Department of Energy
Washington, D.C. 20545

INSTRUMENTATION (CHAPTER 7) WORKING MEETINGS - ADDITIONAL INFORMATION FOR THE CLINCH RIVER BREEDER REACTOR PLANT

September Item 54, November item 4
Auxiliary Feedwater System

QUESTION CS421.4

Figure QCS421.4-1

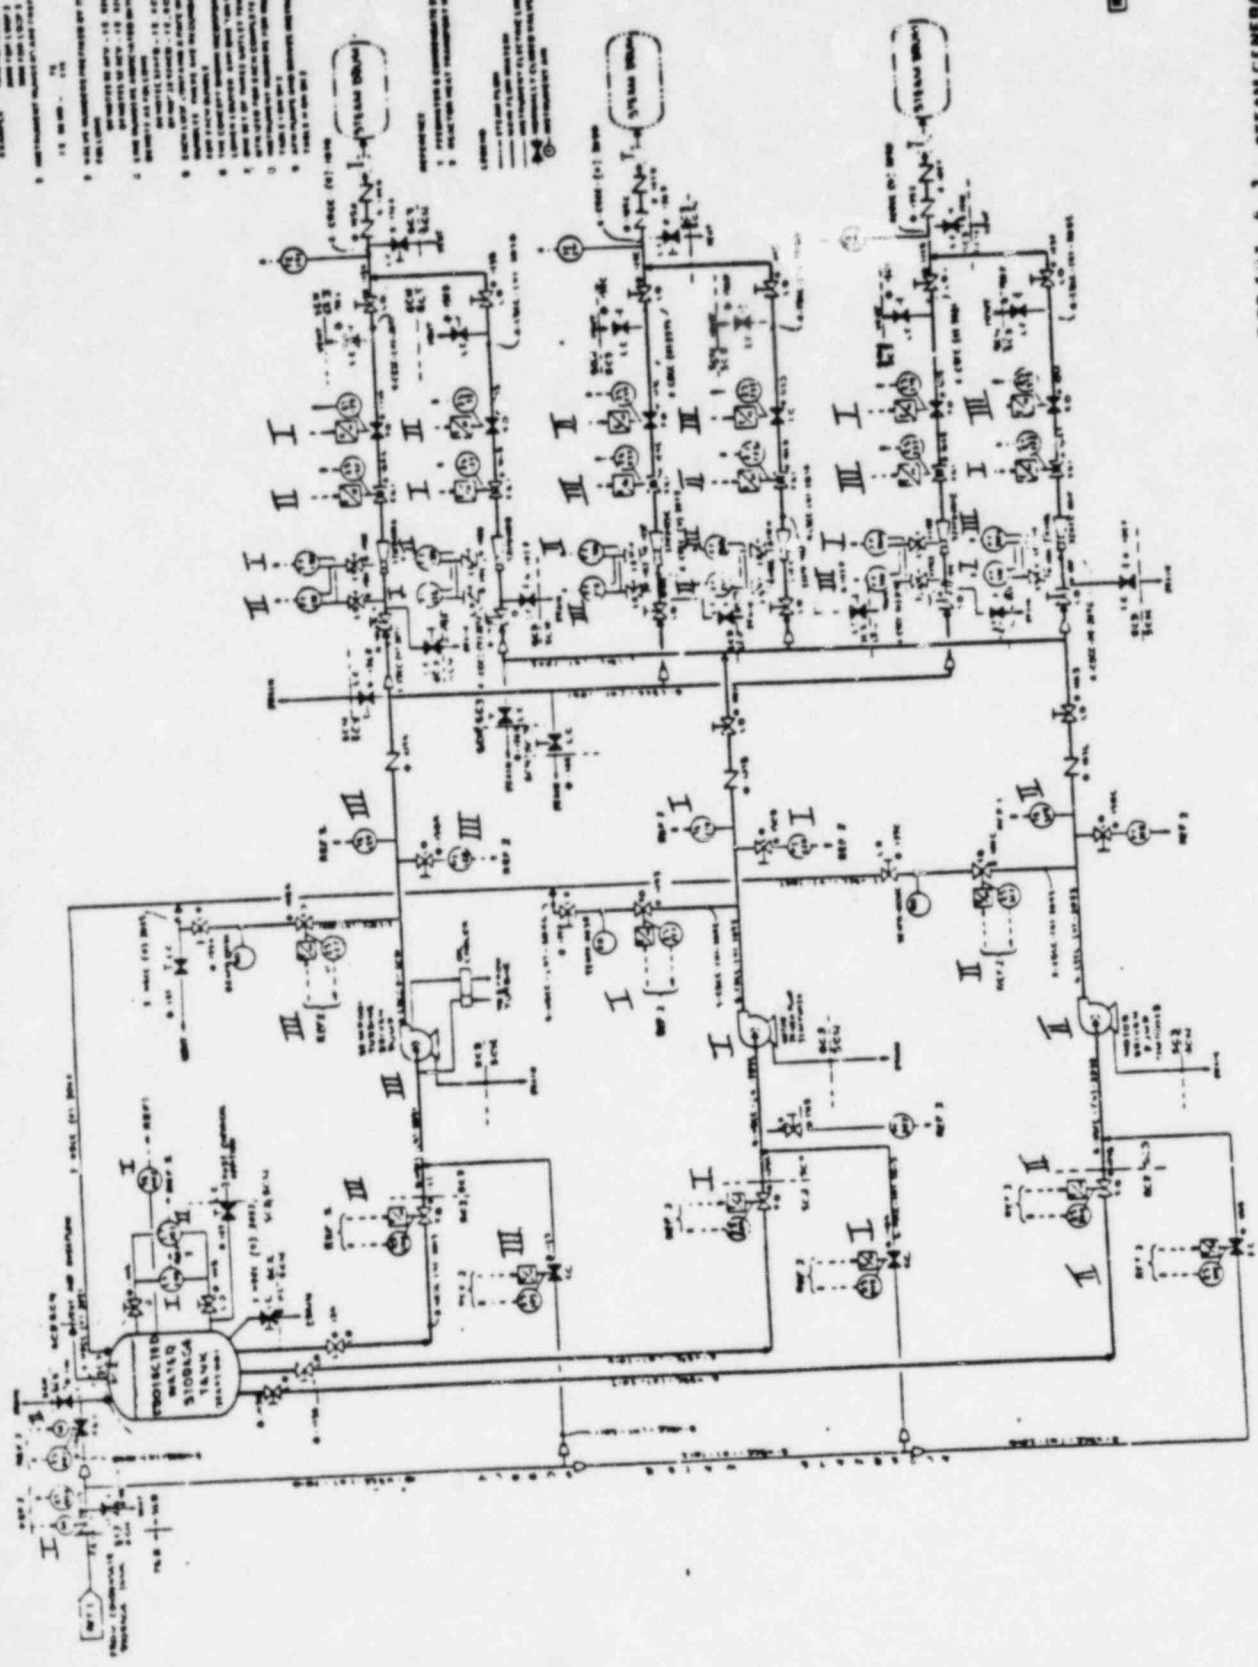
Amend the Q421.4 response to provide a description rationale defining why the AFWS valves have no realistic common mode failures, discuss over voltage and under voltage conditions and alarms. Consider a steam or feedline break in one loop. Provide valve qualification and design details. The concern is failure of valves in the same power division to assume their deenergized position when required.

The applicant should formally submit a diagram of the auxiliary feedwater system showing the division assignments for all valves and safety grade instrumentation and controls. A discussion should be included to indicate the normal position and position upon loss of power of each valve. In your presentation, and in Section 7.4.1.1.6, credit is taken for the feedwater isolation valve to fail-safe in the open position upon loss of electrical power. Justify this fail-safe analysis for all incidents (i.e., hot shorts, power supply overvoltage, etc.) that could prevent operation of this isolation valve.

Figures 5.1-5 and 5.1-5a of the PSAR (attached) have been marked-up (Figure QCS421.4-1, 2) to show the power division assignments for all valves and safety grade instrumentation of the auxiliary feedwater system. The controls for the devices are not shown. However, the power assignment is the same as that of the valves, louvers, and fan blade pitch control being actuated. The normal position and failure position of the valves are shown in Figures 5.1-5 and 5.1-5a.

As shown in Figure 5.1-5 there are six isolation valves, two in parallel to each steam drum. One valve supplies water from the electric driven pumps, the other from the turbine drive pump, each capable of supplying 100 percent water flow to the steam drum. These two valves are supplied with power from separate Class 1E power divisions. The failure of one valve to open on demand would not result in the loss of water to a steam drum, as the required water would be supplied by the parallel line.

The isolation valves (52AFV103A-F) are closed in normal operation. They open automatically on SGHRS trip or when the steam drum level drops to 8" below normal water level (NWL). Automatic closing occurs when the steam drum level rises to 8" above NWL for the motor driven pump AFW supply and 12" above normal water level for the turbine driven pump AFW supply.

In addition, Figure 5.1-5 shows that there are flow control valves in series with these isolation valves. Each of the flow control valves is supplied with power from a Class 1E power division different from the Class 1E power division supplied to the isolation valve in the same line.

The design provides for failure of the control power to result in a "fail-safe" position (open) for the isolation valve, and an "as-is" position for the flow control valve; therefore, the capability to maintain the AFW supply has been assured.

The wiring and controls for the isolation or flow control valves in the line supplying water to any steam drum are in separate Class 1E power divisions and separation is provided in accordance with IEEE-383. Hot shorts between the two valves supplying the same steam drum will not occur. The only hot short which could occur would be within the same power division between the valve and control circuits. This could result in two of the six isolation valves not opening when called upon. The two valves that fail, being in the same power division supply separate steam drums. Since there is a 100 percent redundant water supply to each steam drum, a failure of two of the six isolation valves would not result in the loss of water to any of the three steam drums. A short between two Class 1E power divisions is not a credible event because of the separation between divisions.

Upon the loss of power the isolation valves are driven to their fail-safe de-energized positions by accumulator pressure, which is released and applied to the bottom of the actuator cylinder. The flow control valves fail in the as-is position. In the unlikely event of a valve, or the even more unlikely event of all valves, in a power division failing to assume their de-energized positions, the operator can manually operate these valves to accomplish a safe shutdown under any set of conditions.

The above has discussed the ability to provide water to the steam drums with the loss of a division of power; however, if there is a break in the feedwater line to a steam generator or a steam line in a steam generator loop, the operator has the capability to remotely close the flow control valve in series with the isolation valve that failed in the open position. In addition, the operator could also manually operate the valves to isolate the AFW supply from the pipe break.

If there is a break in the auxiliary feedwater line to one steam generator and a failure in the division of power that does not feed the affected loop, the loop would isolate the break. The other loops would continue to supply feedwater to the steam drums as the isolation valve affected by the power failure would go to its failure position (open) and the affected flow control valve would remain in its normal position (open). If the power failure is such that it prevents an isolation valve from obtaining its failure position, the affected flow control valve on the parallel line would remain in its normal position (open), and flow would be controlled by the opening and closing of the isolation valve on the other division of power. The flow would be maintained to the steam drum by either the motor driven or turbine driven pumps.

The AFWS valves are safety-related and are qualified to perform their function in the worst accident environmental condition they are expected to experience. The isolation valves and the flow control valves are provided by different suppliers and use different types of actuators. The isolation valves are gate valves with electro-hydraulic actuators that have internal accumulators to provide the reserve energy to take the valves to their failure position. The flow control valves have internal trim designed to permit throttling the flow as well as providing shutoff capability. These valves have an electro-hydraulic actuator that permits modulation of the valve position and fails in position. Because of the different valve suppliers and the different type of actuators, ~~no~~ common failure mode is anticipated.
